The Williams Inn

Alternatives Analysis

Town Review Comments – 13 November 2015

Option A Master Site Plan

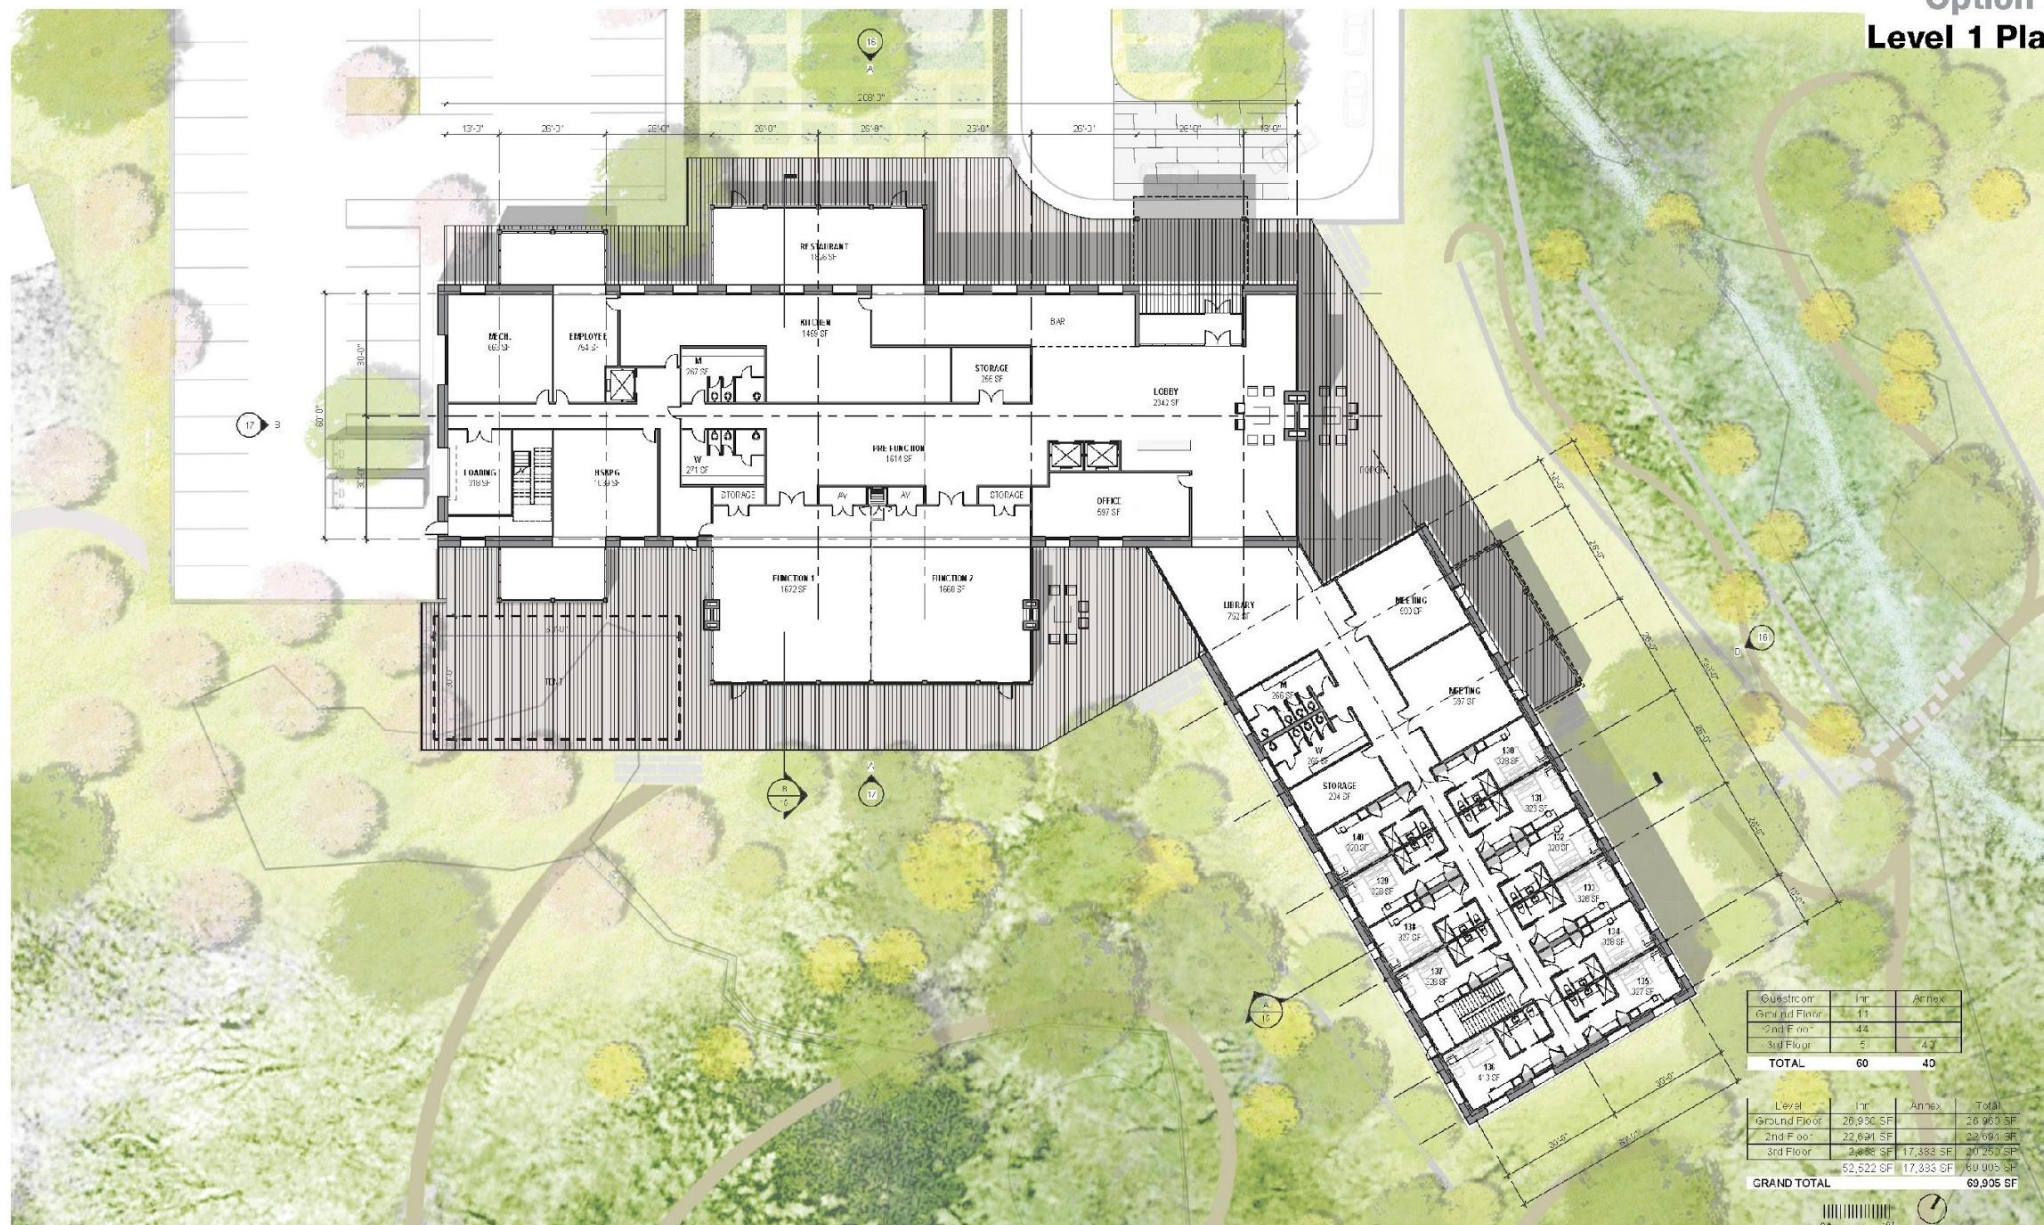
- Both Police and Fire Departments expressed concern about fully restricting the existing Denison Park Drive such that the hotel has only one main access in Option A. They would prefer having a secondary access. This can be a bollard protected emergency only lane similar to the installation at Weston Field. The same observation holds for the Annex as shown in Option B.

- The Fire Department notes that access to two sides of the buildings is necessary for appropriate fire protection. In both options, the annex shows little to no accessibility for fire lanes.

**Option B
Master Site Plan**

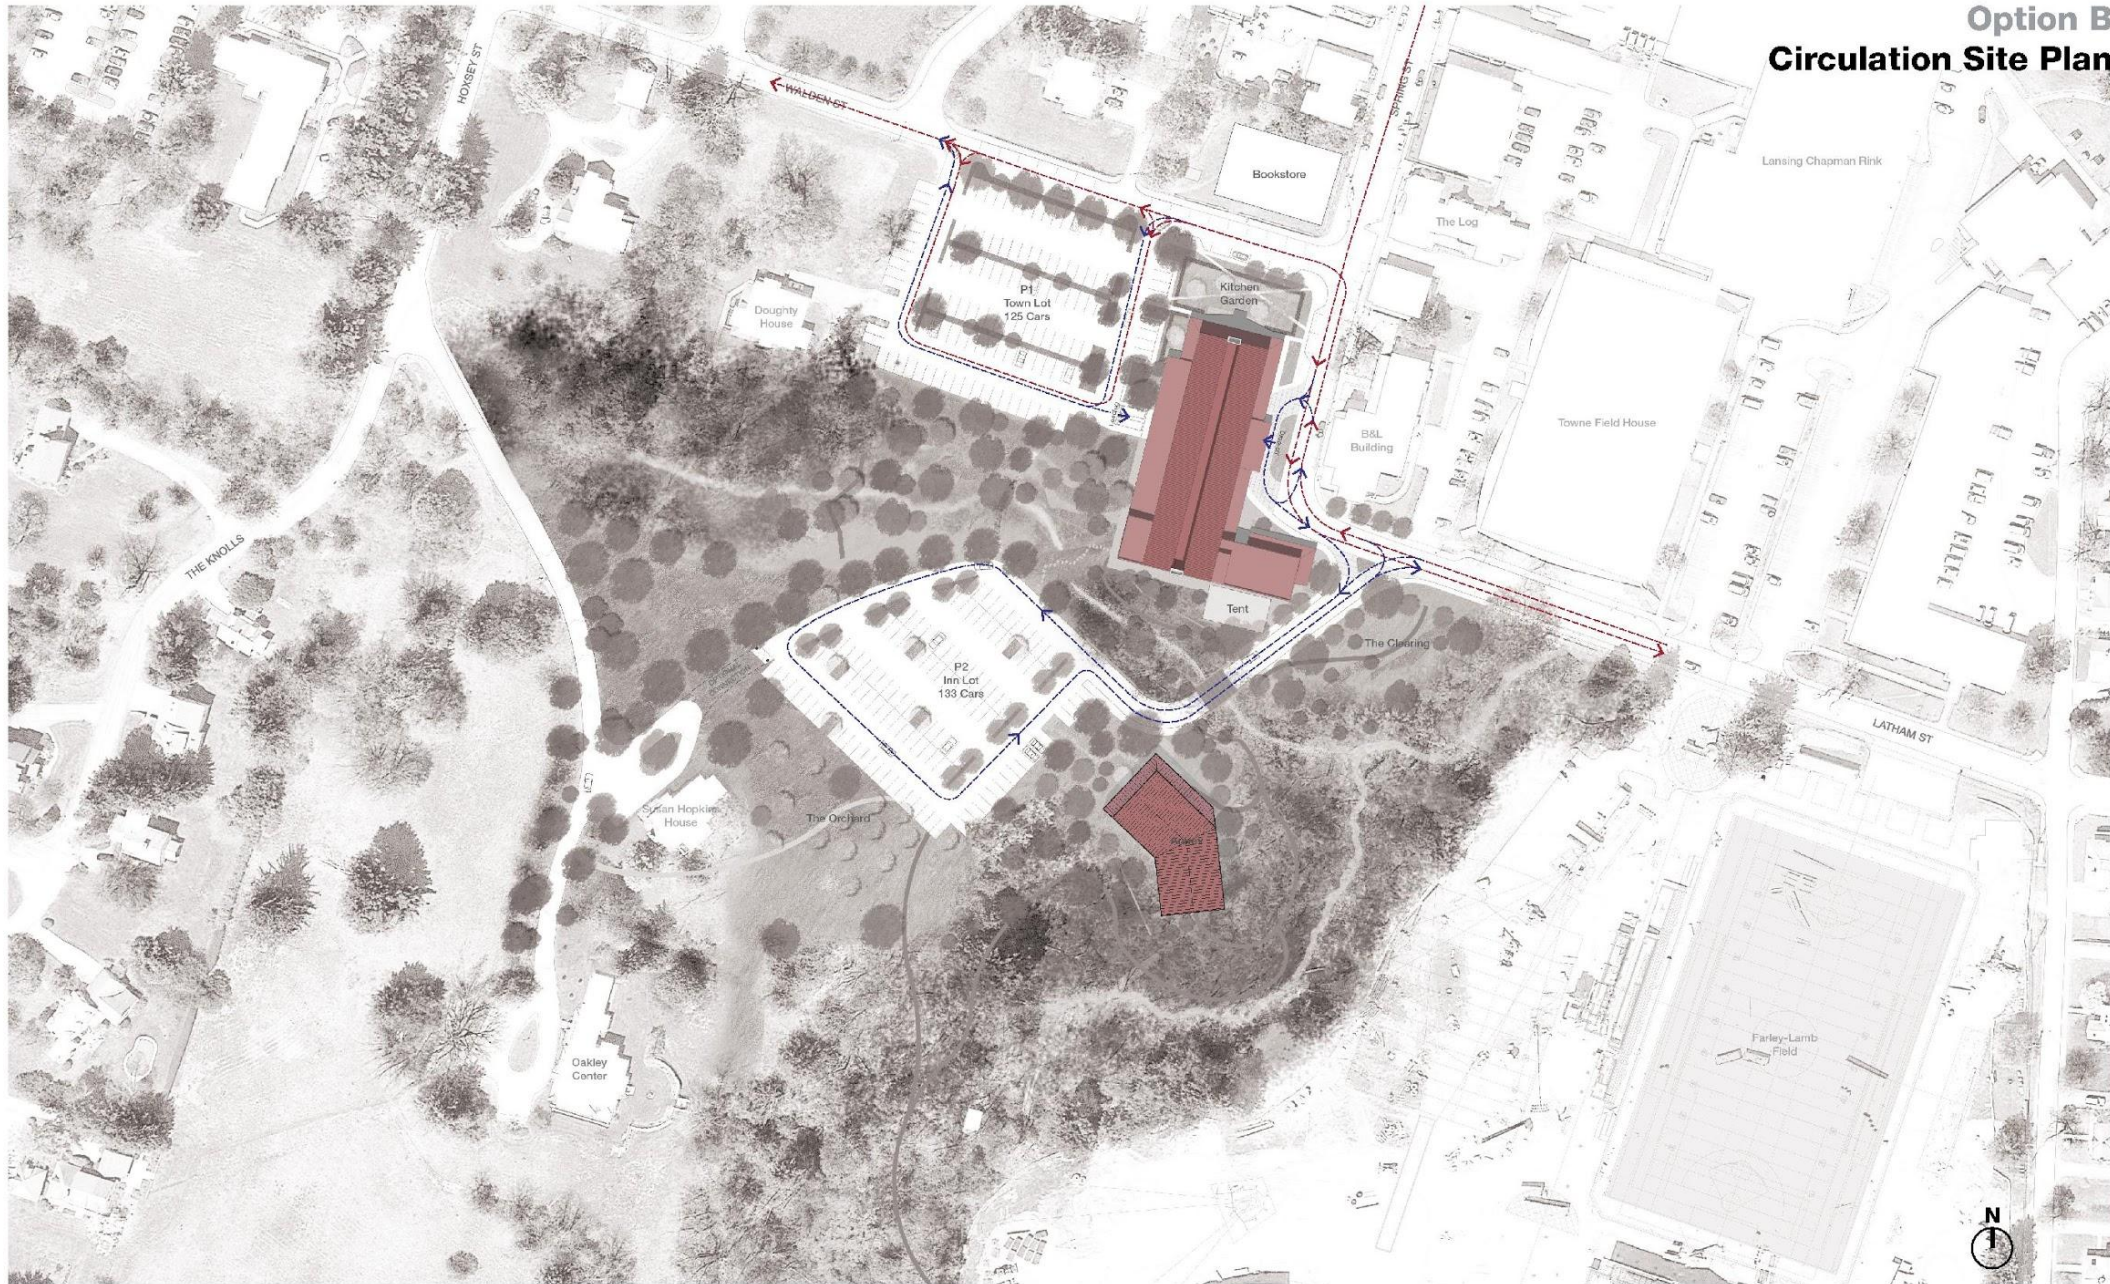
- Option B seems very problematic from a traffic perspective with congested drop off and bus loading areas.
